Access Compliance Report Public Rights-of-Way (Curb Ramps)

Main Street: IRVINE_BLVD Cross Street: BRITTANY_WOODS_DR Location: SW

ADA ID: RPRK211014150036 Ramp Type: Type 4 - Parallel Initial Pass/Fail: Pass Overall Compliance: No Severity Score: 5

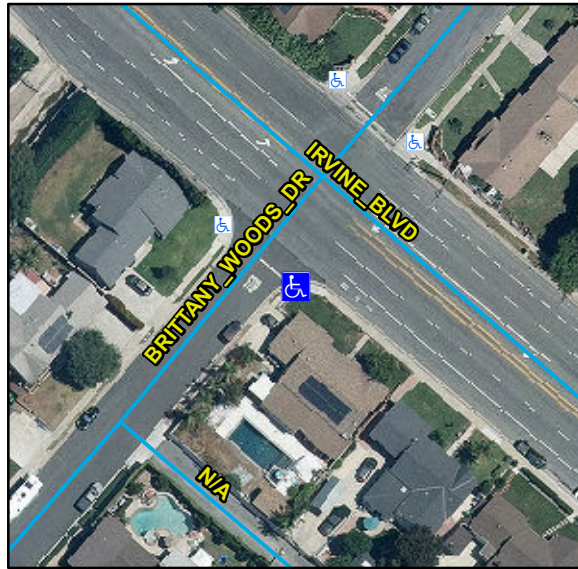
N/A	Ramp Inside Crosswalk 1	N/A	N/A	Ramp Inside Crosswalk 2	N/A
	Crossing 1 Slope (%)	11		Crossing 2 Slope (%)	5.8
	Crossing 1 Cross Slope (%)	1.9		Crossing 2 Cross Slope (%)	2.3
Yes	Gutter Ponding	No	Yes	Curb Slope	5.5
Yes	Gutter Lip Height (in)	0		Road Run Slope (%)	2.3
No	Gutter Run Slope (%)	5.8		Road Cross Slope (%)	6.8
Yes	Gutter Cross Slope (%)	1.9	Yes	Perpendicular Joint Present	Yes
Yes	Overall Surface Condition	Acceptable			
	Cross Gutter Present?	No		Spandrel Present?	No
	Replace Cross Gutter?	N/A		Replace Spandrel?	N/A

Remove & Replace Landing. Remove & Replace Gutter.
